# 2015 - 2016 Corvette: Service Bulletin: #16-NA-014: Delayed Engagement After Sitting With Engine Off

## #16-NA-014: Delayed Engagement After Sitting With Engine Off - (Jun 28, 2016)

**Subject:** Delayed Engagement After Sitting With Engine Off

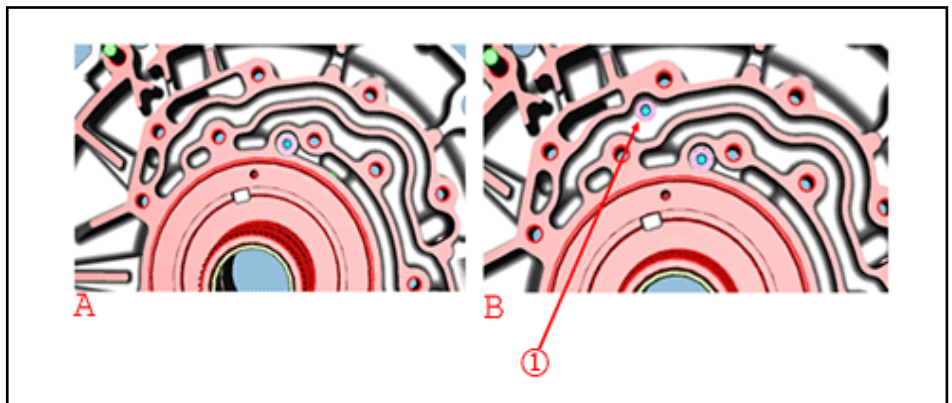
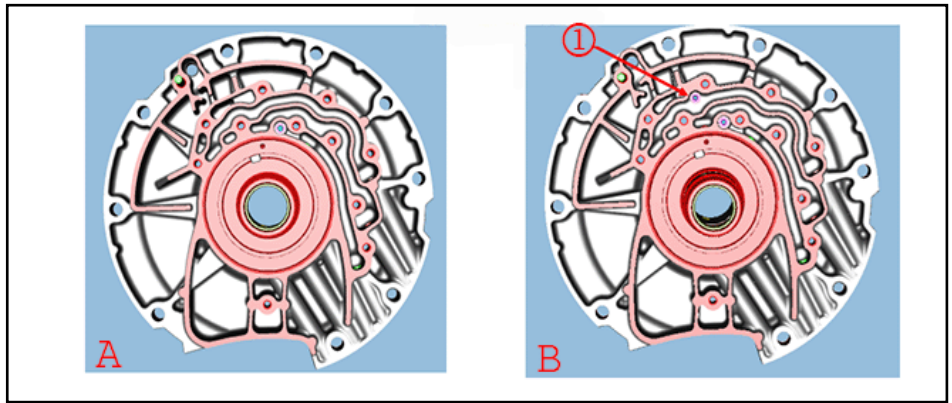
(A)

Old stator support asm

(B)

New stator support asm

**Note:** The new stator shaft support assembly has a second check ball (1) added (see illustrations).

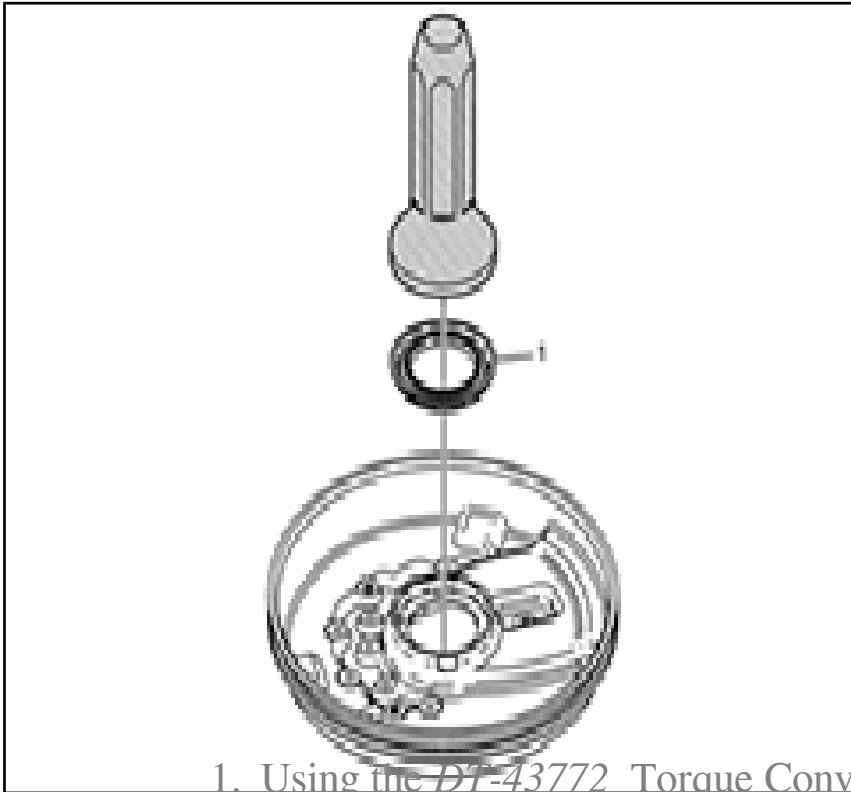
(A)

Old cover - 8L90 Only

(B)

New cover - 8L90 Only

**Note:** The casting void has been eliminated from the underside of the cover for the 8L90 only (see illustration). The 8L45 is not required.
